Access Compliance Report Public Rights-of-Way (Curb Ramps)

Main Street: S_DAISSY_ST		Cross Street: AVENDALE_BLVD		Location:	SW
ADA ID: RPRK21111172424	Ramp Type:Type 1 - Perpendicular	Initial Pass/Fail: Pass	Overall Compliance: No	Severity Score:	15

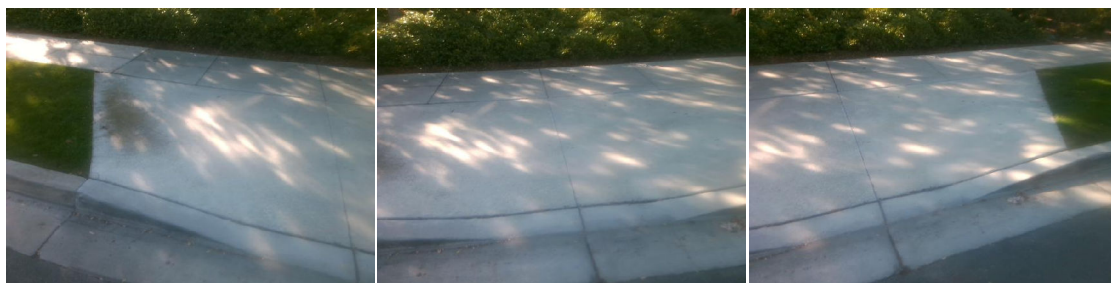
Compliance	Description	Data	Compliance	Description	Data
N/A	Ramp Length (in)	77	N/A	Flare Type LT	
Yes	Ramp Width (in)	48			Sloped
Yes	Ramp Run Slope (%)	7.1	N/A	Flare Slope LT (%)	7.4
Yes	Ramp Cross Slope (%)	1.8	N/A	Flare Traversable LT	No
N/A	Landing Present	Yes	N/A	Flare Type RT	
N/A	Landing Length (in)	48			Sloped
Yes	Landing Width (in)	48	N/A	Flare Slope RT (%)	13.6
Yes	Landing Run Slope (%)	1.9	N/A	Flare Traversable RT	No
Yes	Landing Cross Slope (%)	1.8	No	DWS Provided	No
N/A	Landing Movement Obstructed?	No	N/A	DWS Contrast	N/A
	Landing Movement Type	N/A	N/A	DWS Length (in)	N/A
N/A	Landing Shared	Yes	N/A	DWS Full Width	N/A
N/A	Clear Space	N/A	N/A	DWS Offset Left (in)	N/A
N/A	Clear Space To Crosswalk (in)	N/A	N/A	DWS Offset Right (in)	N/A
N/A	Marked Crosswalk 1	No	N/A	Marked Crosswalk 2	N/A
	Crossing 1 Direction	E		Crossing 2 Direction	N/A
	Marked Crosswalk 1 Width (in)	N/A		Marked Crosswalk 2 Width (in)	N/A

N/A	Ramp Inside Crosswalk 1	N/A	Yes	Ramp Inside Crosswalk 2	N/A
	Crossing 1 Slope (%)	1		Crossing 2 Slope (%)	N/A
	Crossing 1 Cross Slope (%)	2.5		Crossing 2 Cross Slope (%)	N/A
Yes	Gutter Ponding	No	No	Curb Slope	13.8
Yes	Gutter Lip Height (in)	0		Road Run Slope (%)	N/A
No	Gutter Run Slope (%)	7.8		Road Cross Slope (%)	N/A
Yes	Gutter Cross Slope (%)	0.3			
Yes	Overall Surface Condition: Acceptable		Yes	Perp Joint Present	Yes
	Cross Gutter Present?	No		Spandrel Present?	No
	Replace Cross Gutter?	N/A		Replace Spandrel?	N/A

Remove & Replace Entire Ramp. Remove & Replace Gutter.

R304.2.2, R305, R304.5.4, STD 1115
